APPLICATION NAME: BOWDENS SILVER MINE AMENDMENT  
APPLICATION NUMBER: SSD5765  
**POWERLINE RE-ALIGNMENT BY GHD ...NO SETOUT PLAN**

APPLICATION NAME: BOWDENS SILVER MINE AMENDMENT  
APPLICATION NUMBER: SSD5765  
**DECEPTIVE PRESENTATION; INTENTION BY PROPONENT TO AVOID SCRUTINY**

Figure 4 : Proposed alignment plan view.

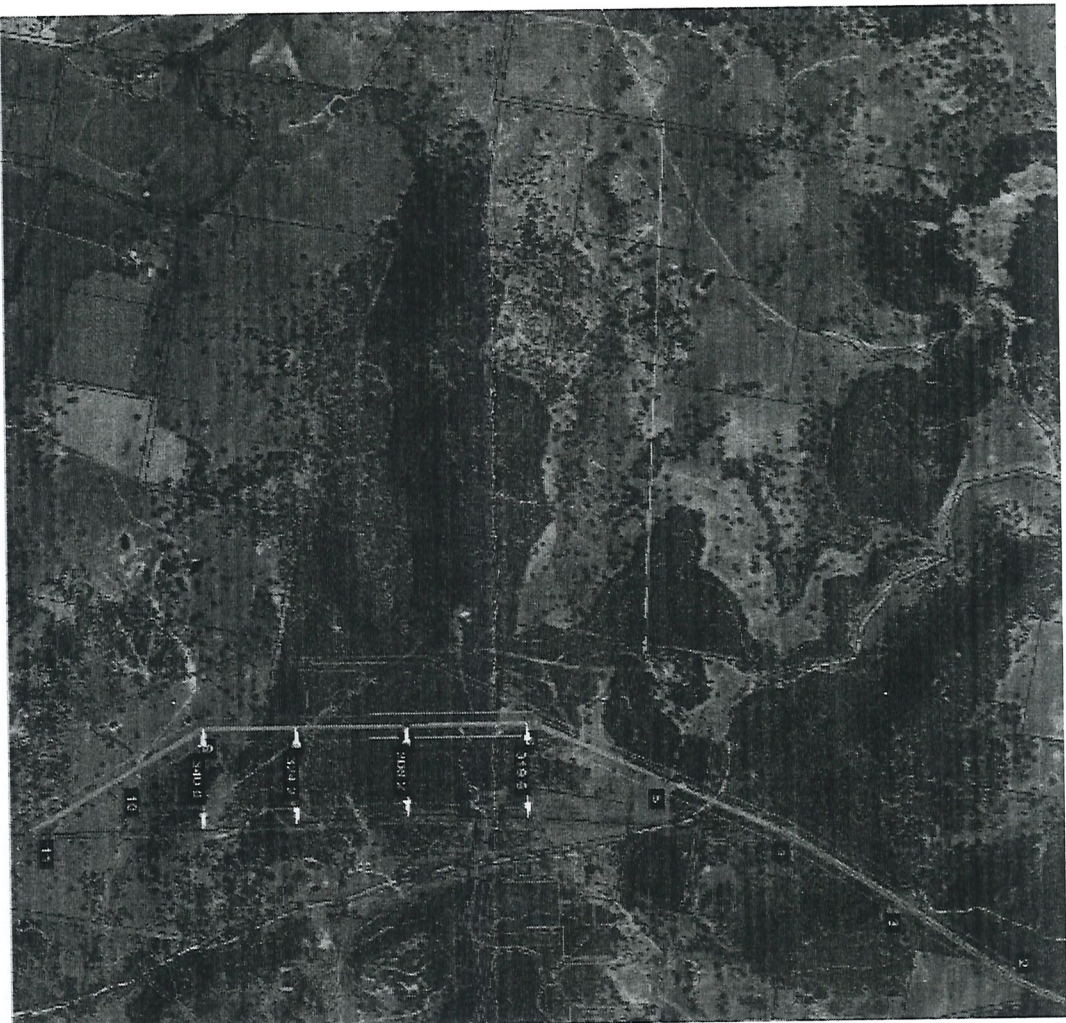
GHD one of the biggest and most famous engineering consultancies have dropped the ball. All that they show and call a 'plan' is a portion of an air photo with a few lines across it. There is no scale, not even a North point. It's been called plan view but it's not a plan it's a marked-up photo. It's a lopsided presentation, the relocated line and subject of the 'plan' is located off centre in any case.

The lack of scale and any other reference point that it is IMPOSSIBLE TO KNOW WHERE THE PROPOSED POWERLINE IS !

The point of this exercise and a lot of administrative etc time is to approve a new route. It has not been defined so we don't know where it is. Thanks GHD.

A simple diagram such as below would describe it. (centre line of the existing conductors, a start point at the Lue Road property line and a few measurements and deviation angles).

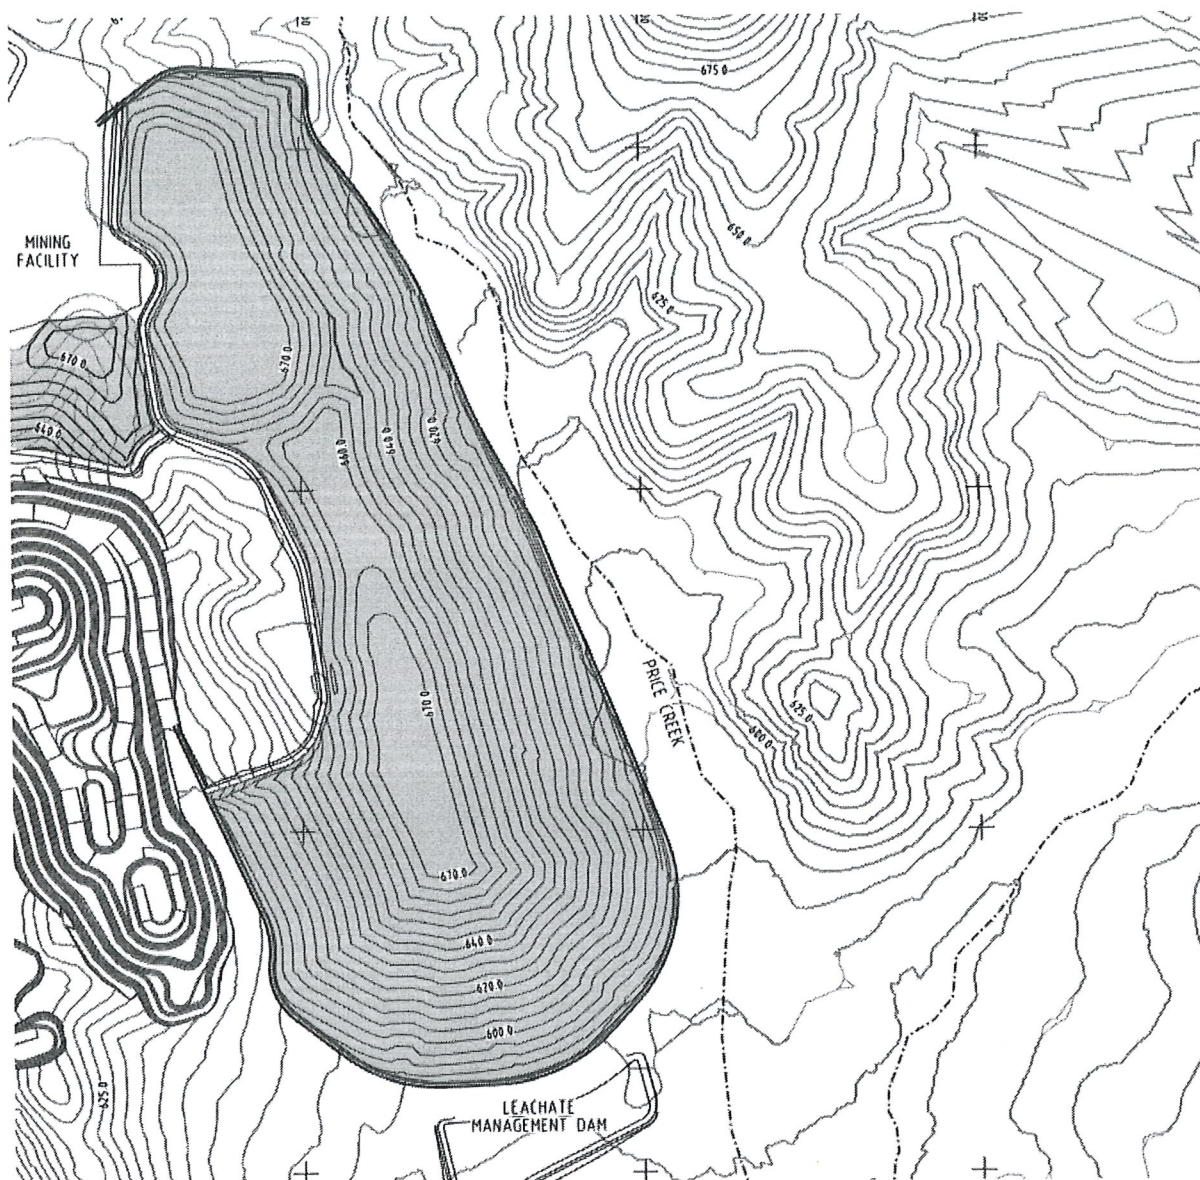
The attached map of Corkery authorship shows on the right the native landform and on the left the monolith of the WRE. The straight and equi-spaced contours of the WRE are a contrast to the topographical variety of the native landscape. Bowdens and Corkery are either blind or dishonest.

It may be noted that natural conditions (largely in terms of rainfall) require drainage way every 200 to 300 metres in the native landscape. Bowdens propose NO DRAINAGE. Erosion as gullying has to be the only outcome.

Figure 2.1

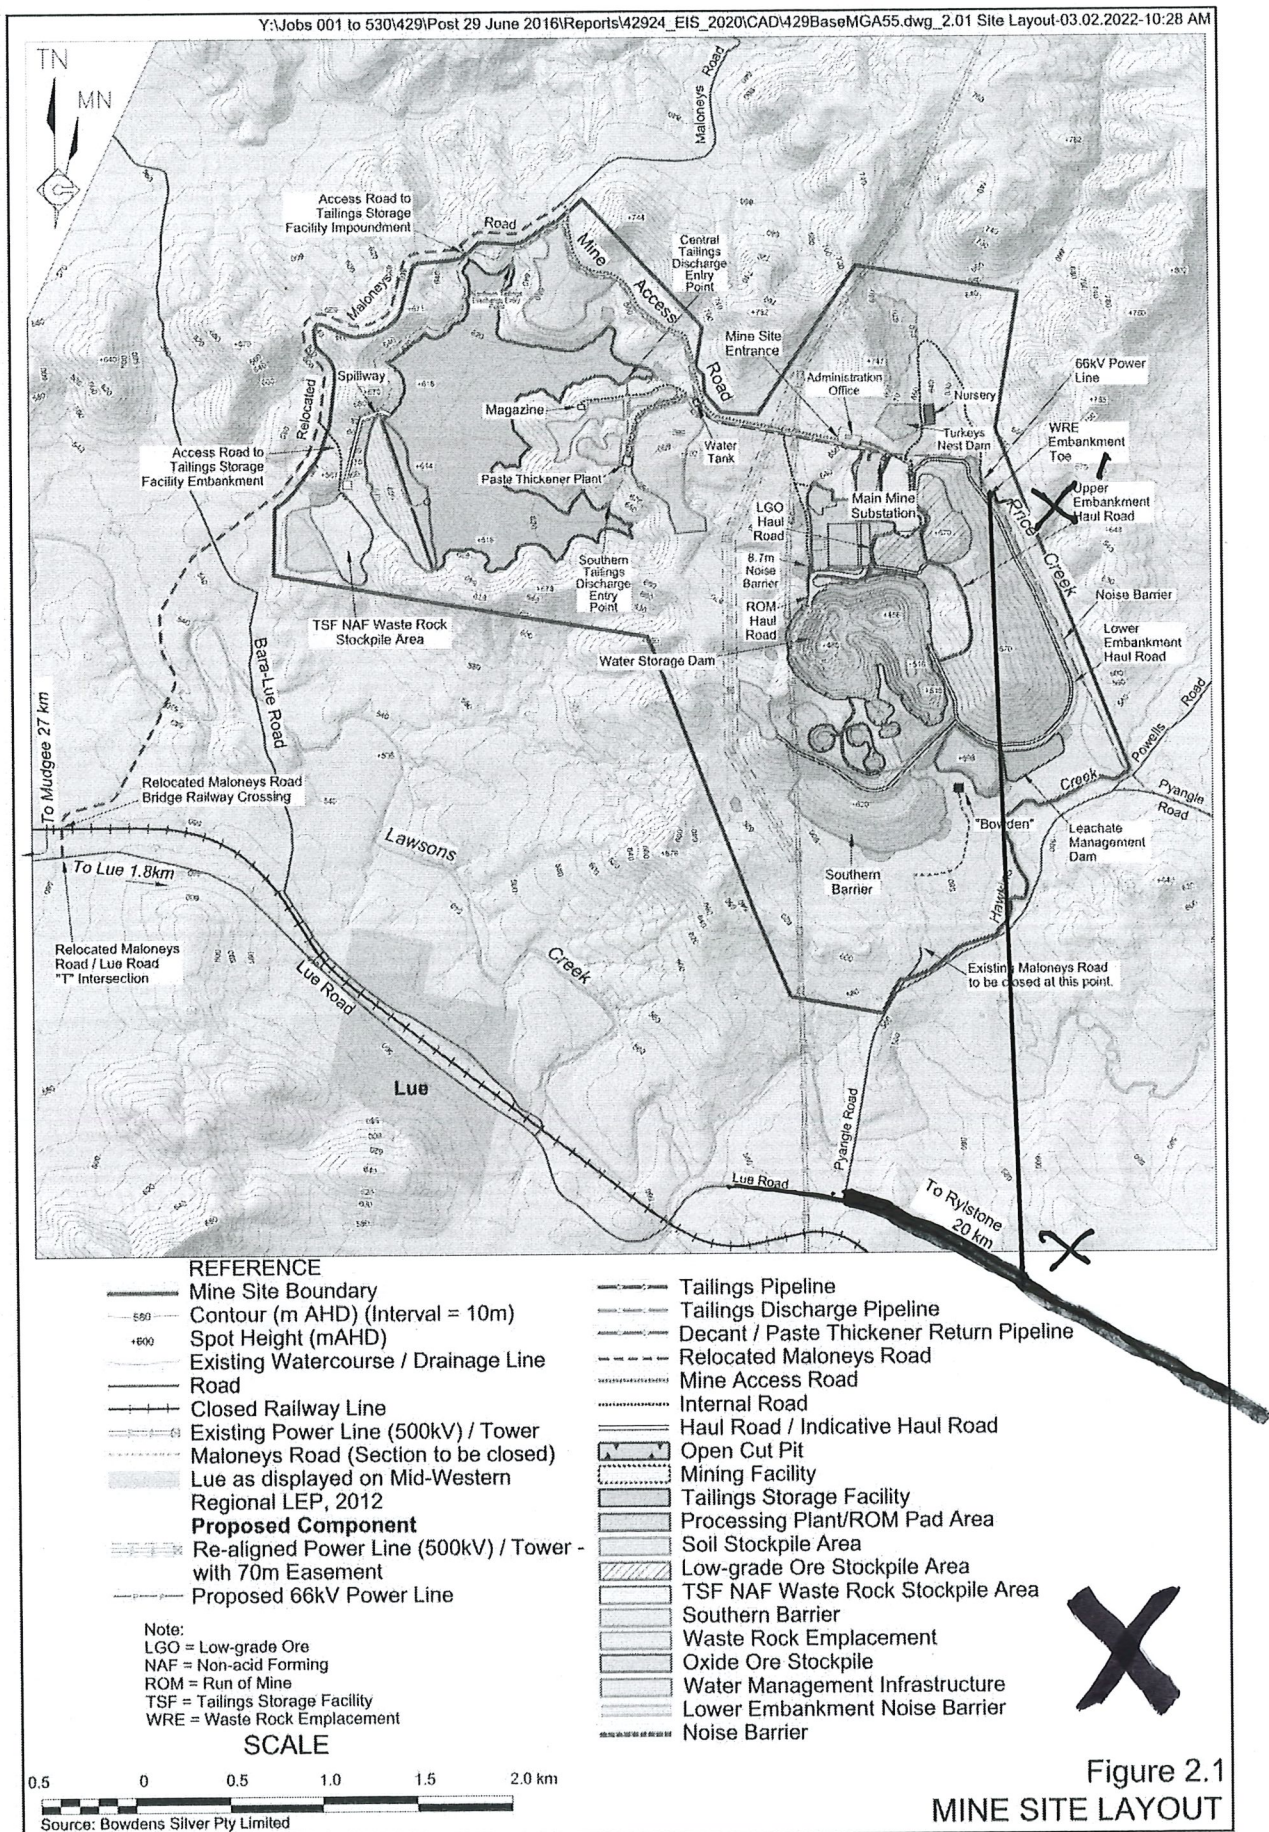
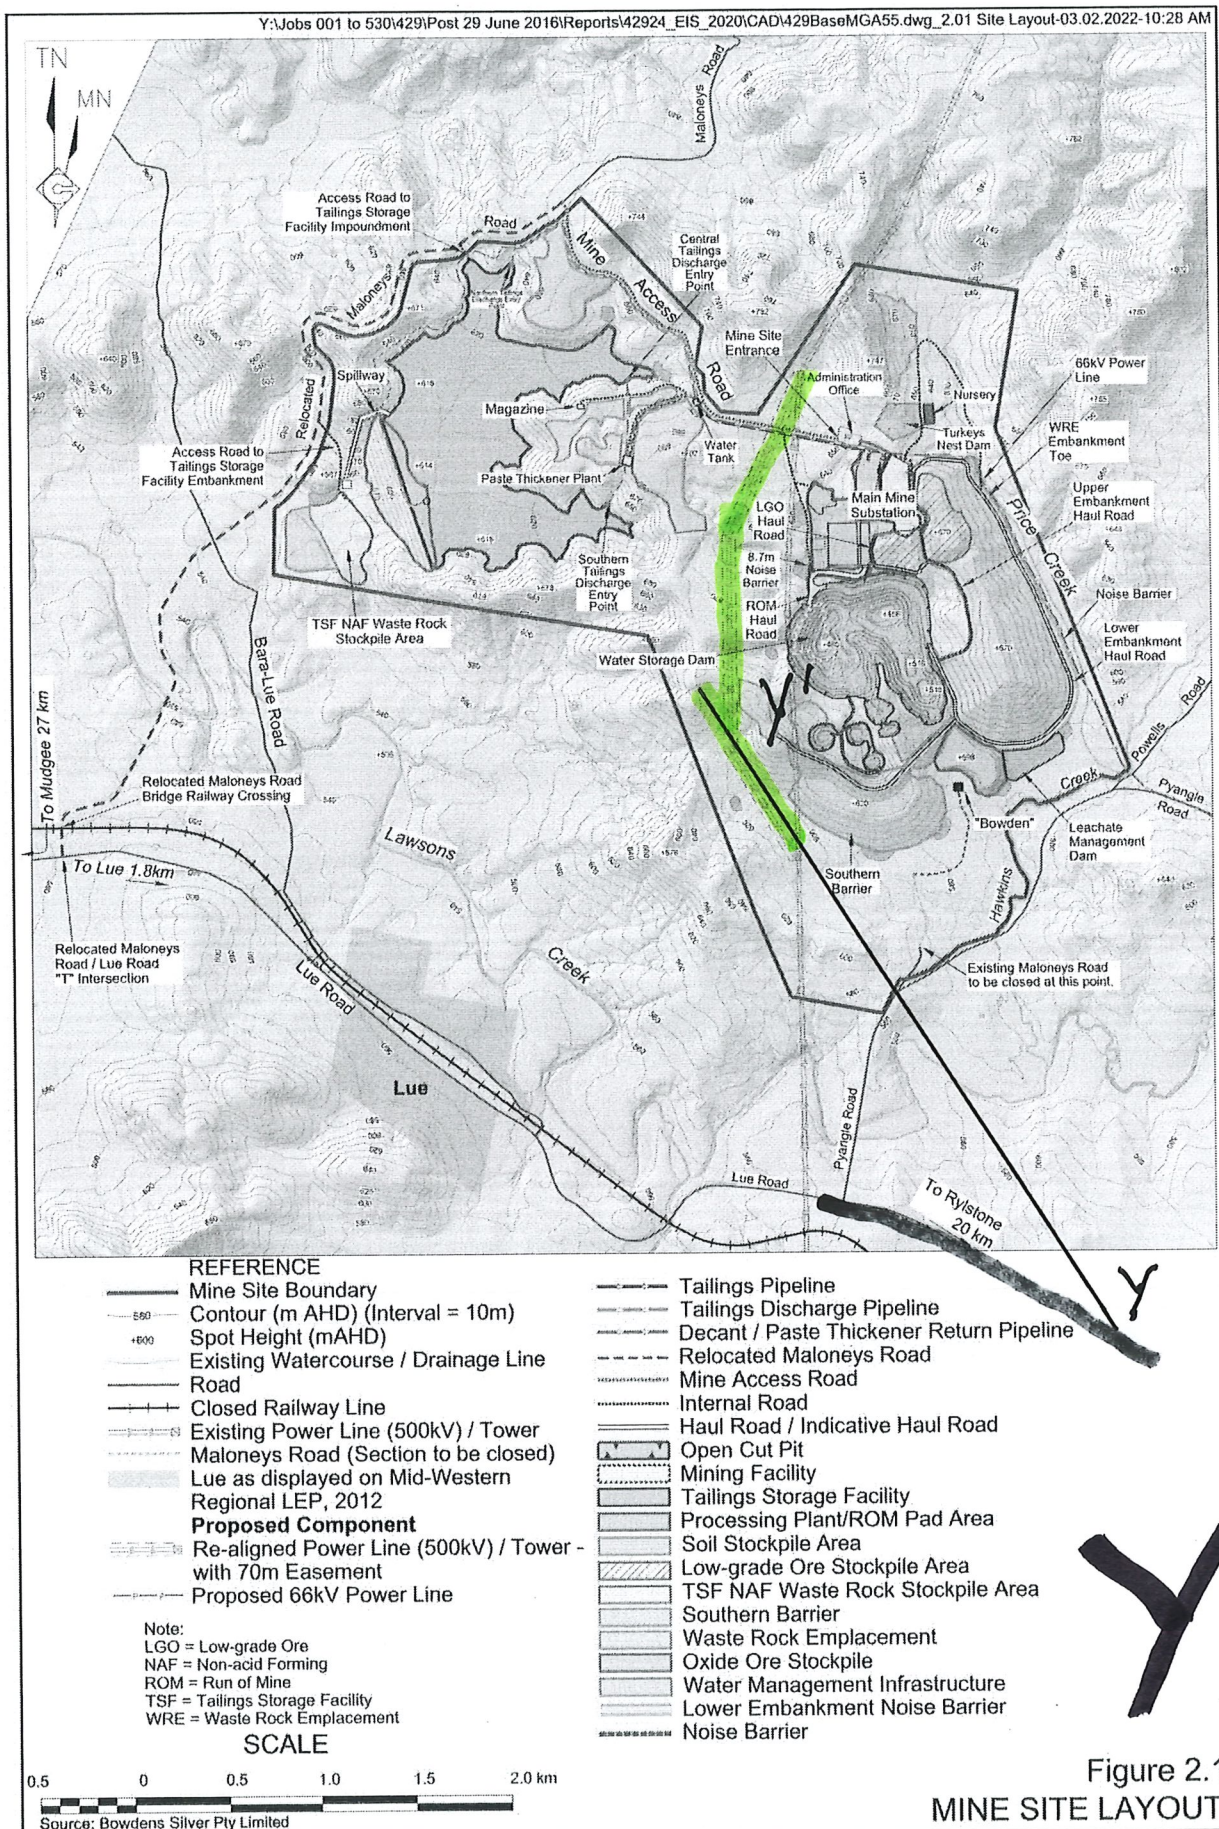
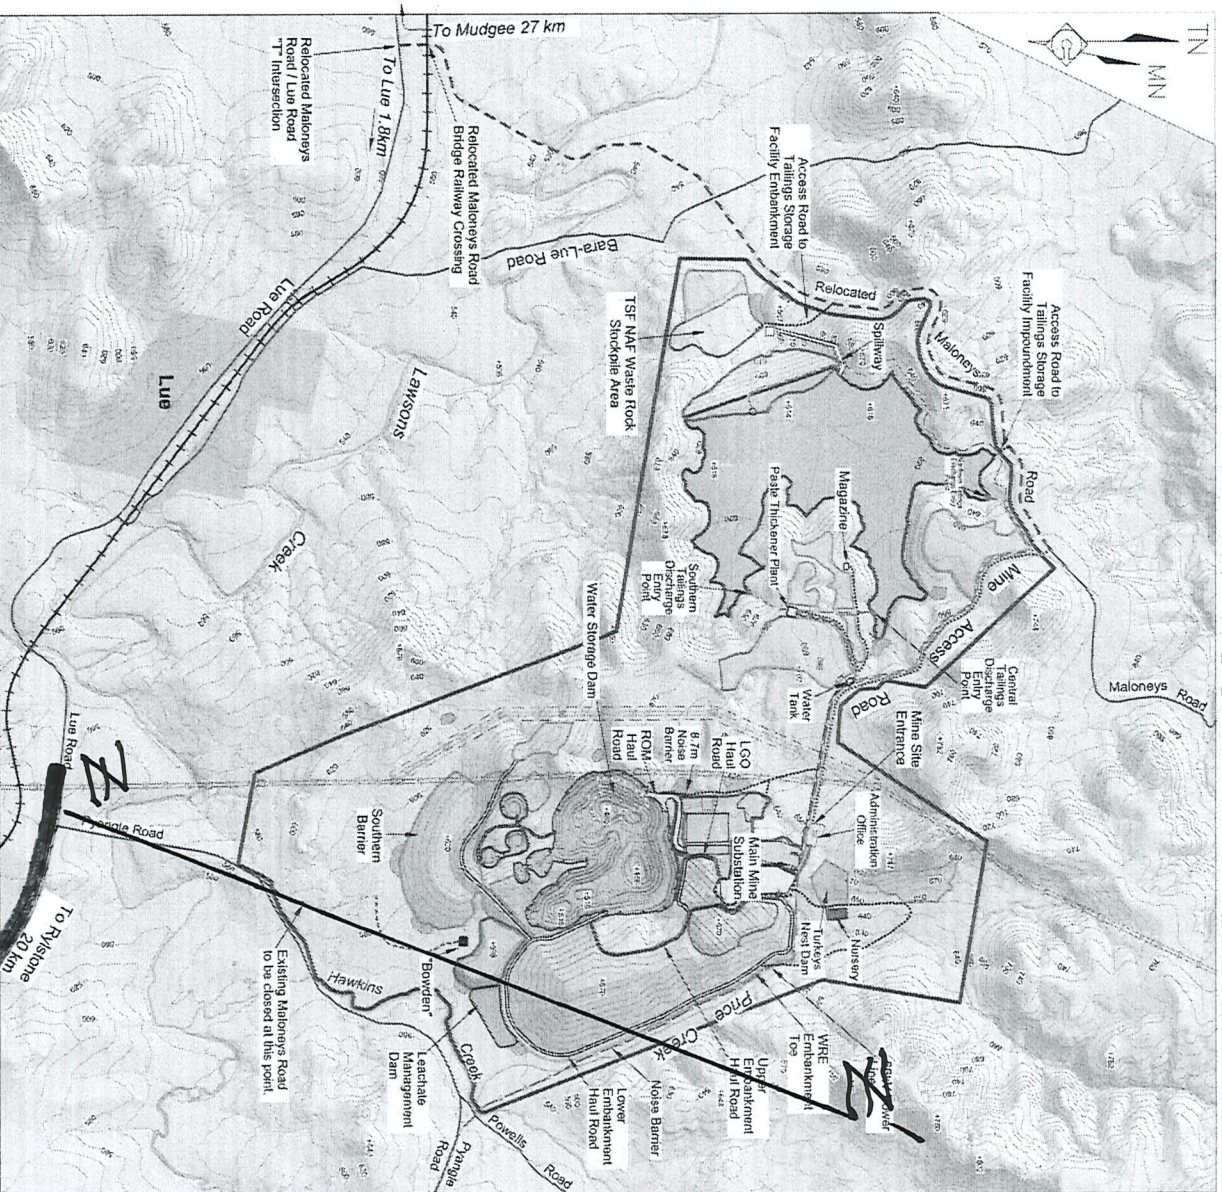
The Blood Gushing from the Skull is found elsewhere. Please find attached 3 marked-up 'Mine site layouts'. I have labelled them X, Y, and Z.. Each of these represents a target of Visual Impact and therefore is a subject which should have been reported and analysed by Lamb, but hasn't. Each has major visual impacts proposed to be caused by Bowdens if it were to be approved as presented.

Drawing X shows the 'windscreen' view (section XX') across the Lue Road/ Locheilly flats to and through the WRE. This will show how dominant and visually damaging the engineered form of the WRE is. It has to have the footnote that Bowdens intend to NEVER reshape the thing to be conforming with adjacent natural Landform.

Drawing Y shows the windscreen view from the Lue Road/ Locheilly flats to the first section of the relocated power line (current proposal). The view is straight up the bare 70 metre wide scar. The section line YY' marks the line of sight.

Drawing Z shows the WRE in its context of the native landform. Lamb and Corkery would not show this (Section ZZ') for fear of embarrassment.
